SERVICE BULLETIN

ID No. SB 26-004
Ref. No. TSB 001-26
Release Date 7-16-2026

SB 26-004 2015-2020 MY COE CAC INLET HOSE

PARTS

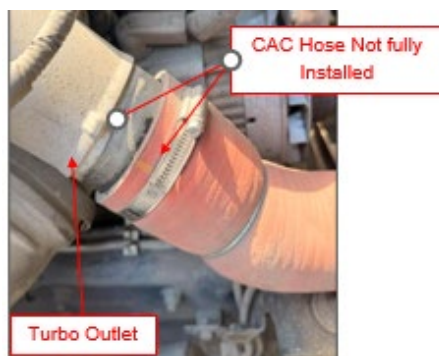
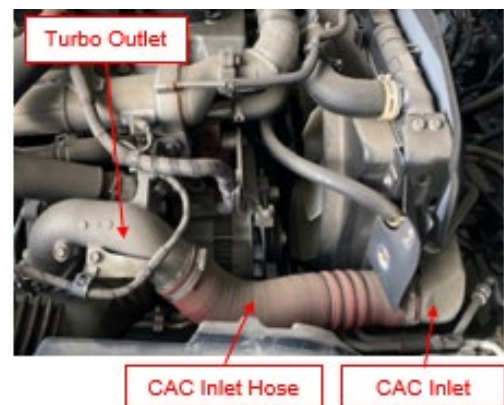
If any of these conditions are present, follow the inspection procedure and inspect the CAC inlet hose between the turbo outlet and the CAC inlet for correct installation and damage. If damage or installation issues are found, replace the CAC hose and clamps with the updated hose following the repair procedure below.

PART NUMBER	PART DESCRIPTION	QUANTITY
9003460049	Hose Clamp	3
1734278350	CAC Inlet Hose	1

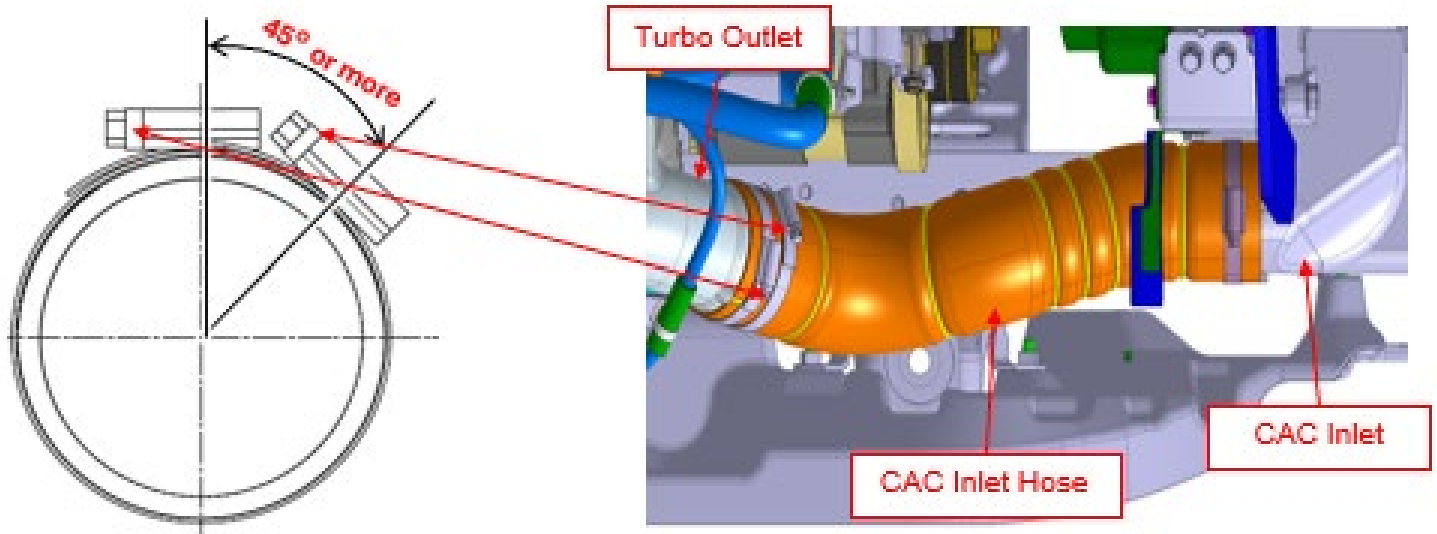
1. Remove and discard the existing CAC inlet hose and hose clamps. Install the enhanced CAC hose (Part No. 1734278350) using 3 new hose clamps (Part No. 9003460049). Install two hose clamps on the turbo outlet end of the hose and one on the CAC inlet end. The clamp screws must be positioned 45 degrees (or more) apart. Reference the diagram below. Tighten the clamps to the specified torque. Once all 3 clamps are tightened, re-torque the clamps a second time to the specified torque.

Specified Torque: 5 ft-lb (6.3 Nm)
